## Landscape Referral Response

<b>Application Number:</b>	DA2022/0340
<b>Date:</b>	11/05/2022
<b>Responsible Officer:</b>	Thomas Burns
<b>Land to be developed (Address):</b>	Lot 361 DP 700858 , 21 Parkview Road FAIRLIGHT NSW 2094

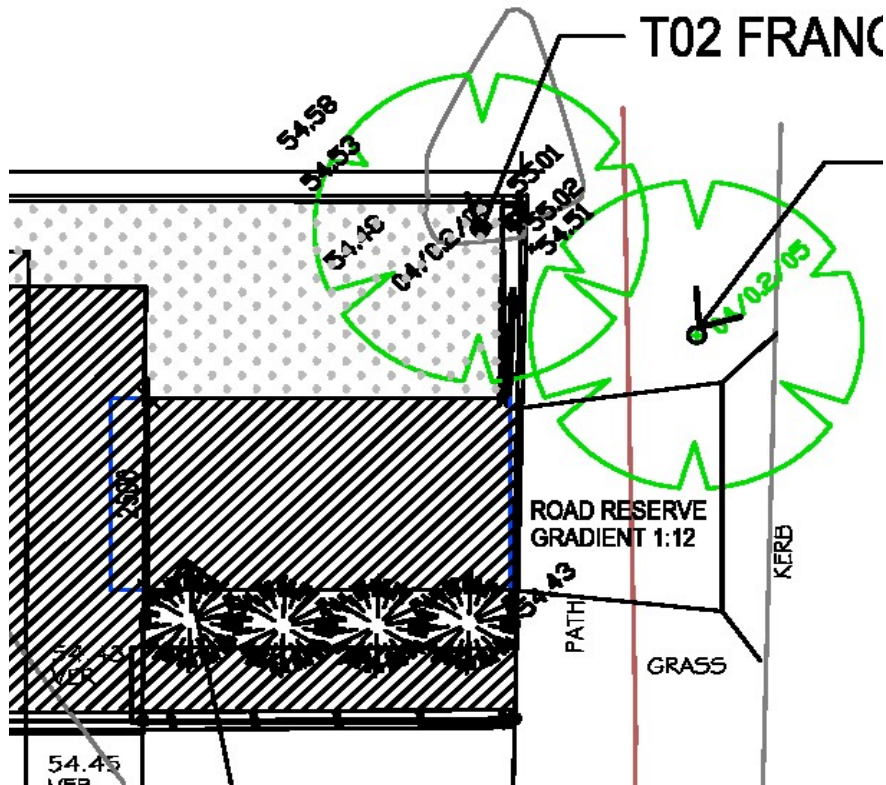
The plans indicate that the new driveway crossover is to be located adjacent to an existing street tree, though the tree is indicated for retention.

Concern is raised regarding the proximity of the crossover to the tree and it is recommended that the crossover be relocated further south of the tree and butt up to the entry path to the dwelling. This would

require deletion of a small planted area indicated on the plans between the path and the drive, which seems to serve little purpose, particularly in relation to exit from a vehicle from the passenger side (if car is parked front first).

Subject to relocation of the crossover further away from the street tree, no objections are raised with regard to landscape issues subject to conditions.
